CALL NO. 100
CONTRACT ID NO. 241306
ADDENDUM # 1

Subject: Breathitt County, NHPP 0151 (090)
Letting March 21, 2024

- (1) Added - Traffic Management Plan - Pages 583A-583L of 649
- (2) Revised - Plan Sheets U-039, U-041, U-042, U-044, U-045, U-047

Sheet No.	U-039
City of Jackson - Utility Relocation	BREATHITT COUNTY, KY - KY15, ITEM NO. 376.00
Date	2023-08-17
Drawn By	JCM
Scale	AS SHOWN
Job No.	933.40

THE HPDE PIPE SHALL NOT SUPPORT WEIGHT OF VALVES AND APPURTENANCES. ALL VALVES AND FITTINGS MUST BE SUPPORTED WITH STANDS.

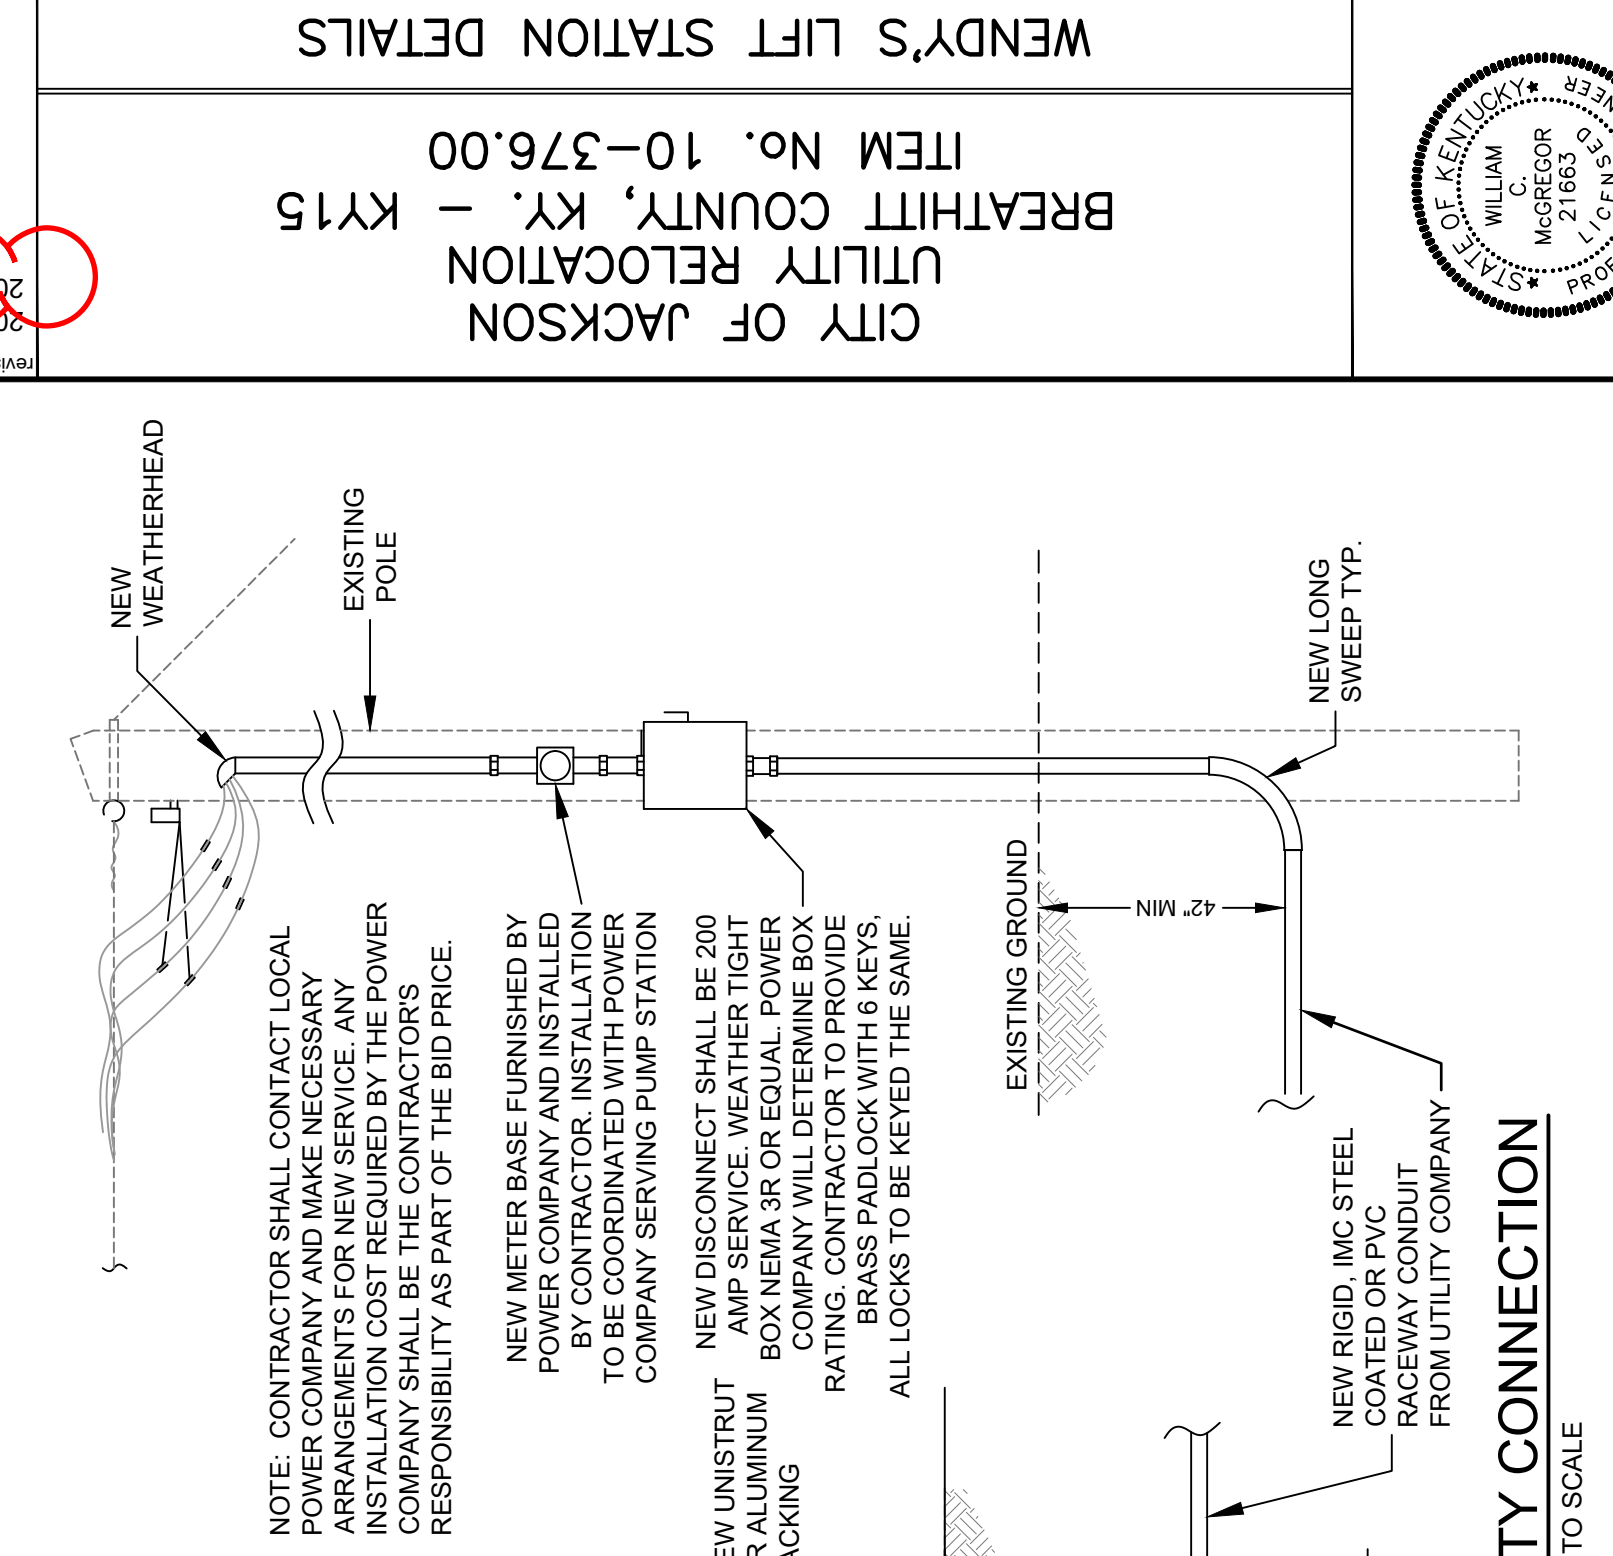
2023-11-17 RELOCATED WET WELL DRAIN TO WET WELL (JCM)
 2024-02-20 ADD 1 CHANGE TO DUCTILE IRON PIPING IN LIFT STATION.
